Joseph M. Farley Nuclear Plant Units 1 and 2  
Response to Request for Additional Information Related to  
Request to Revise Technical Specifications – Containment Equipment Hatch

**Joseph M. Farley Nuclear Plant Units 1 and 2  
Response to Request for Additional Information Related to  
Request to Revise Technical Specifications – Containment Equipment Hatch**

**Response to NRC Request for Additional Information**

**Enclosure 2**  
**Figure 1**  
**Air Intake Locations and Release Points**

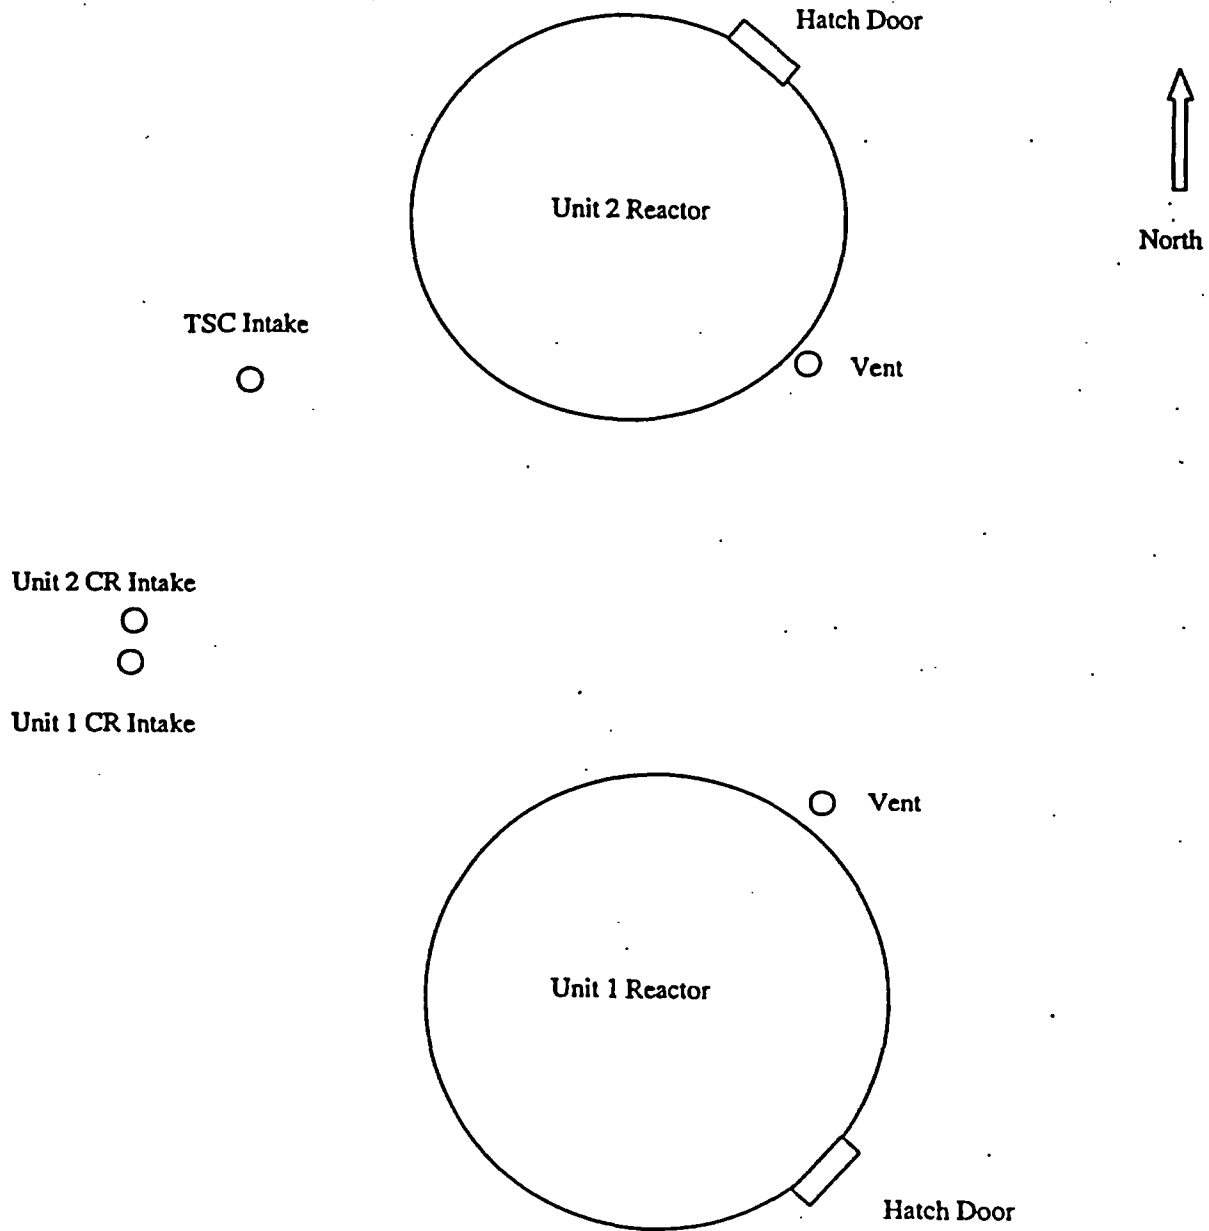
Describe inputs, assumptions and bases: [a] Please describe the specific inputs, assumptions and bases used with the ARCON96 methodology. A copy of the ARCON96 printouts is acceptable to show inputs. [b] Was the physical height of the release location assumed? [c] Are the distances the shortest distance from the postulated release location to the intake location? [d] Are all directional inputs defined in terms of true north? References to figures showing structures, dimensions, and distances may also be helpful in describing the postulated transport of the effluent. [e] If the figures are drawn to plant or magnetic north, what is the relationship to true north?

- c. Yes, distances are the shortest distance between postulated release and intake.
- d. Directions are defined in terms of true north and shown in Figure 1 of Enclosure 2. Drawing references used in specifying distances and directions are provided in Table 1 of Enclosure 2.
- e. Directions are defined in terms of true north. No additional information is required.

**Note:** Release point from the reactor was a point on the containment surface closest to the receptor location.
